## Service Kit Instructions

### Series 90

## Replacement of control gasket

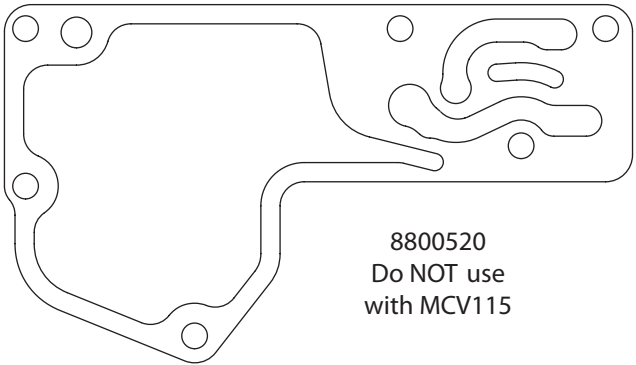
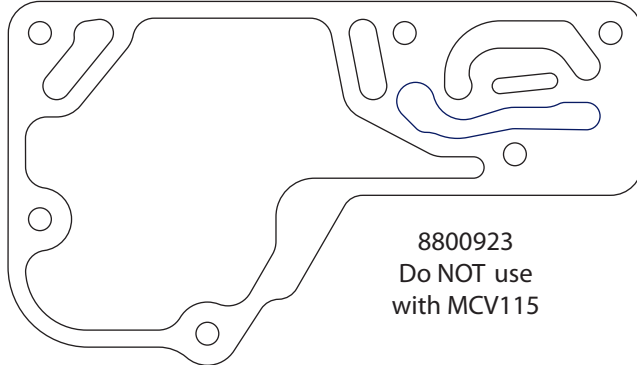
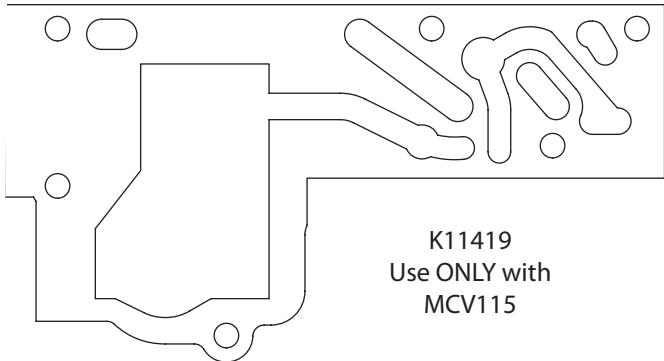
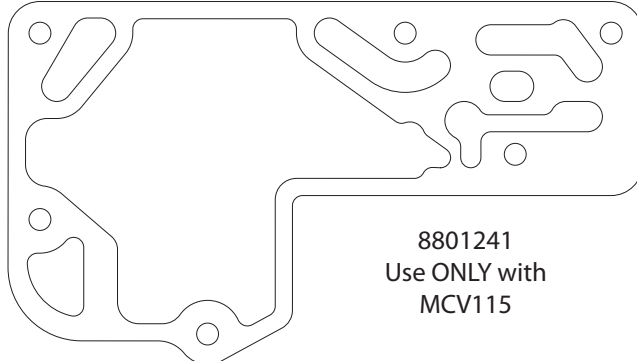
In October of 1992, Sauer-Danfoss began offering a new style hydraulic displacement control (MCV115) that is a direct replacement for the MCV112.

The control gasket also changed, and the new style gasket must be used with the MCV115 control. The old style gasket is to be used with the MCV112 control, all manual displacement controls, and MCV111 electric displacement controls.

Failure to use the appropriate gasket may result in uncontrolled pump displacement.

30cc/42cc/55cc	75cc/100cc/130cc
 <p>8800520 Do NOT use with MCV115</p>	 <p>8800923 Do NOT use with MCV115</p>
 <p>K11419 Use ONLY with MCV115</p>	 <p>8801241 Use ONLY with MCV115</p>
